PIC18F85J90 FAMILY

PIC18F85J90 Family Data Sheet Errata

Clarifications/Corrections to the Data Sheet:

In the Device Data Sheet (DS39770B), the following clarifications and corrections should be noted. Any silicon issues related to the PIC18F85J90 family of devices will be reported in a separate silicon errata. Please check the Microchip web site for any existing issues.

FIGURE 16-10: I²C™ SLAVE MODE TIMING (TRANSMISSION, 7-BIT ADDRESS)

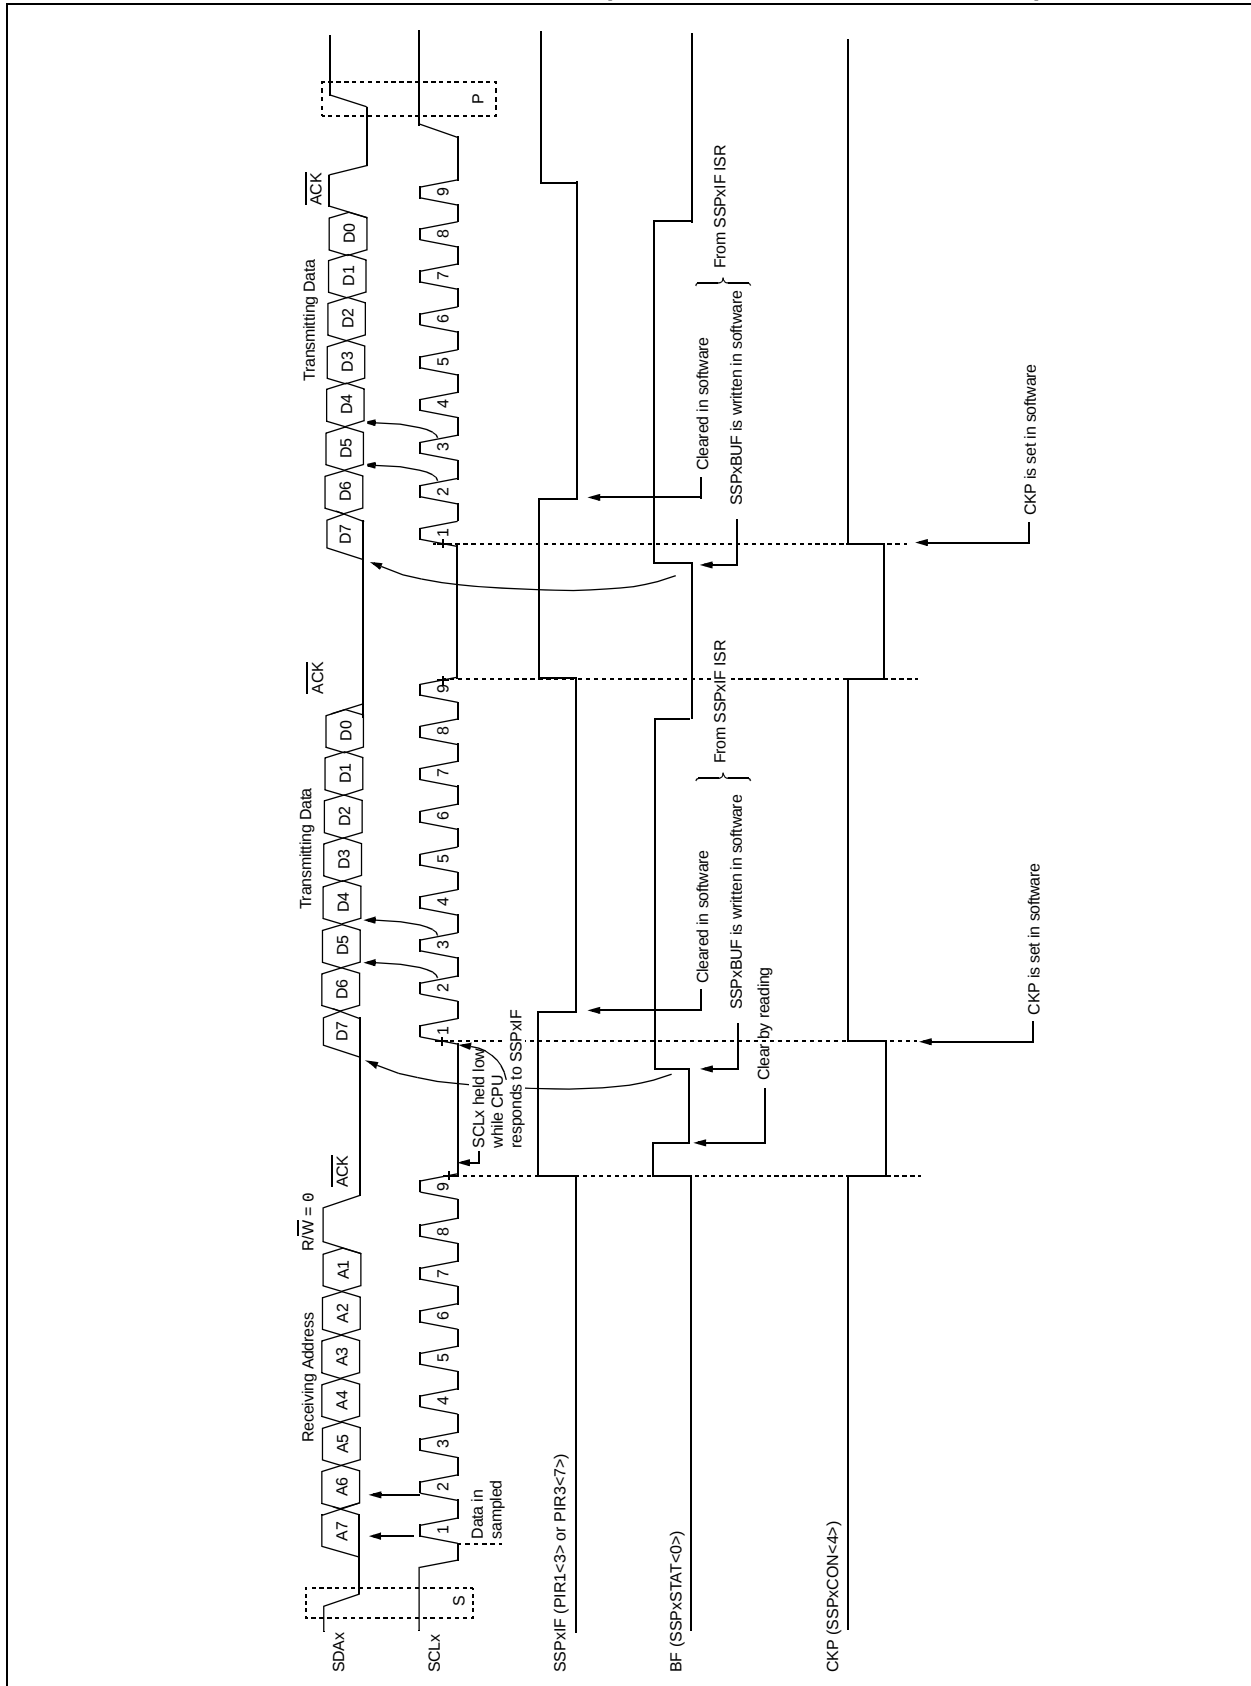
21. Module: Figure 16-10: I²C™ Slave Mode Timing (Transmission, 7-Bit Address)

On page 204, the figure is replaced with the new timing diagram provided in Figure 16-10.

FIGURE 16-24: I²C™ MASTER MODE WAVEFORM (RECEPTION, 7-BIT ADDRESS)

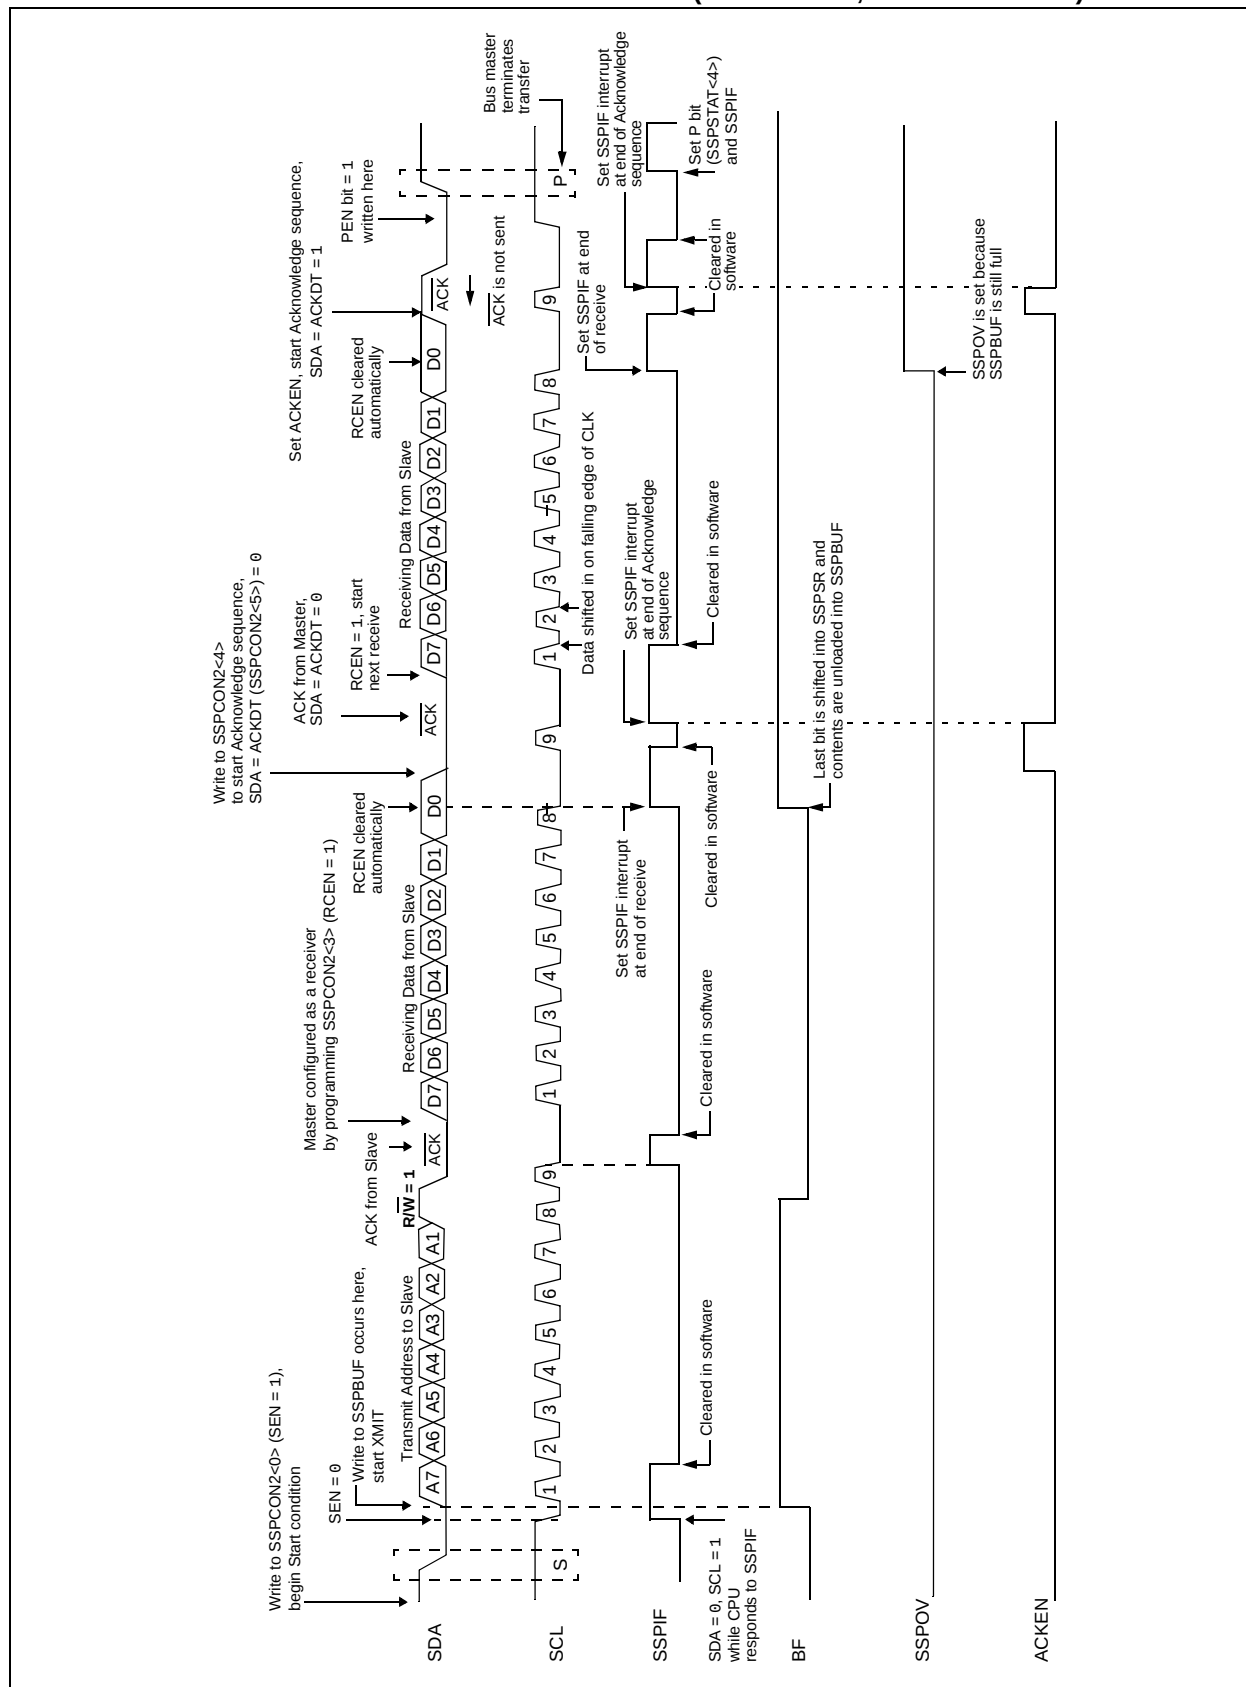
22. Module: Figure 16-24: I²C™ Master Mode Waveform (Reception, 7-Bit Address)

On page 221, the condition ($R/\overline{W}$) when the Acknowledge signal (ACK) is received from the slave, after transmitting the address to the slave, is changed to '1'. The changed value is indicated in bold text in Figure 16-24.
